AGENDA
CITY OF CEDAR FALLS, IOWA
PLANNING AND ZONING COMMISSION MEETING
WEDNESDAY, APRIL 10, 2024
5:30 PM AT CITY HALL, 220 CLAY STREET

TO: Planning & Zoning Commission
FROM: Jaydevsinh Atodaria (JD), AICP, City Planner II
Matthew Tolan, Civil Engineer II
DATE: April 10, 2024
SUBJECT: Preliminary Plat for Panther West Additions (PP23-009)

REQUEST: To approve Panther West Additions Preliminary Plat (PP23-009)
PETITIONER: Brent Dahlstrom, Owner; Brewer Civil LLC, Engineer
LOCATION: The property is located south of Greenhill Road and North of Aldrich Elementary School

PRELIMINARY PLAT FOR PANTHER WEST ADDITIONS TO THE CITY OF CEDAR FALLS, BLACK HAWK COUNTY, IOWA

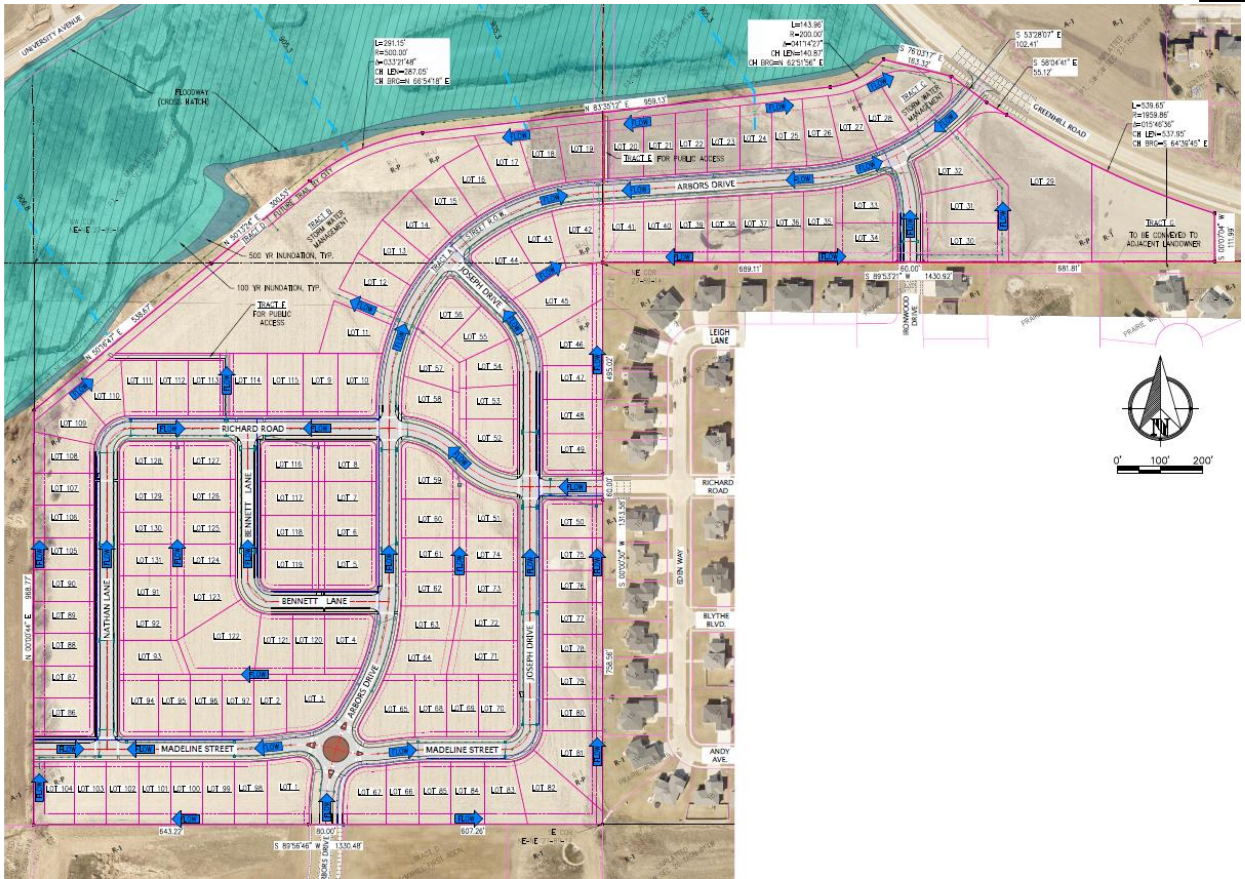
The overall development will utilize two regional detention facilities (Tract B and C on the proposed plat) that will be constructed to collect stormwater from the street network by intakes or captured by overland swales within protected drainage easements to be conveyed to the regional detention area. Tract B will collect the majority of the preliminary plat boundaries and Tract C will collect the far easterly side of the development near the intersection of Arbors Drive and Ironwood Drive. Tract C also accounts for the collection and bypass of the Prairie West Addition detention facility (located south of proposed Lot 29). The Prairie West 2nd Addition basin currently outfalls by overland flow that will be rerouted into the proposed Panther West Addition’s storm sewer network and released into proposed Stormwater Management area (Tract C) with a new outfall into the northerly City property (see image to the for additional reference)

The applicant has added a Drainage Map exhibit in the packet as per request at the last Planning and Zoning Meeting on March 27th, 2024. This exhibit shows how the stormwater will be managed for the entire development. See below image for reference.

PRELIMINARY PLAT - SITE MAP

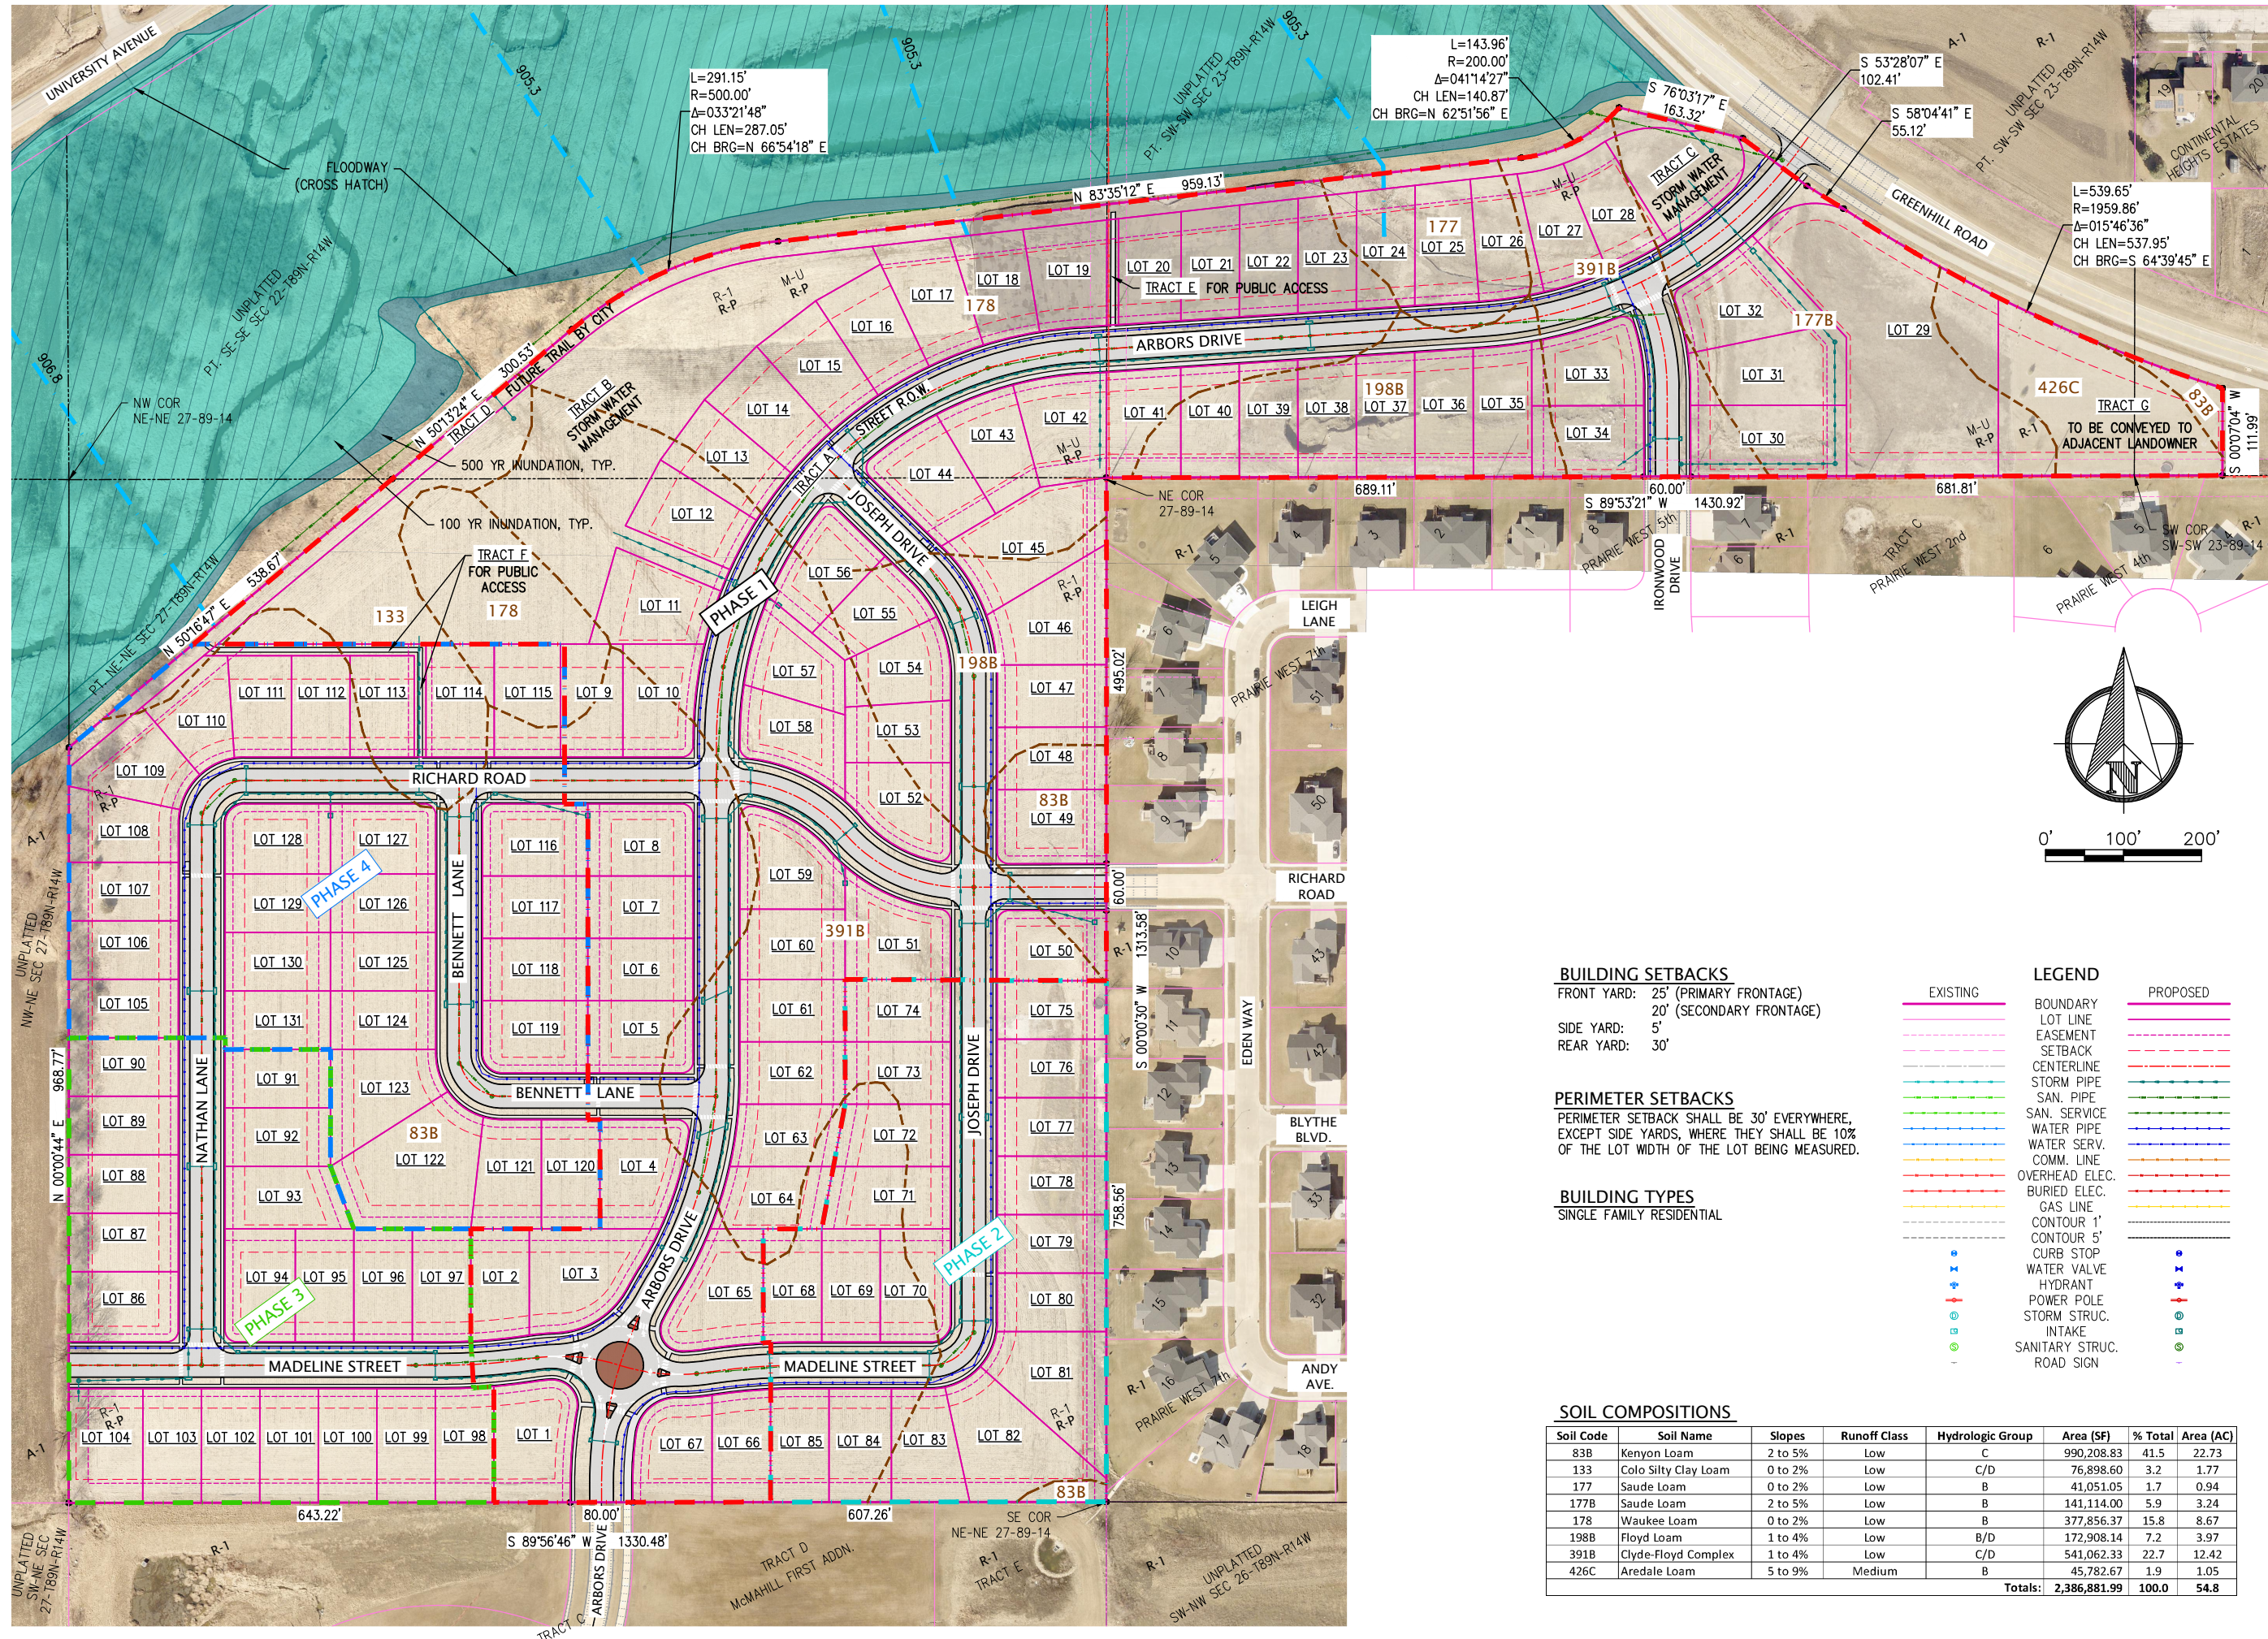
City staff finds that the setbacks will be appropriate for the development being like setback requirements for single-family dwellings in the R-4 District. All setback information is labeled on the plat for additional reference. However, staff notes that a label showing the perimeter setback line along the periphery of the proposed subdivision must be shown on sheet PP-2.
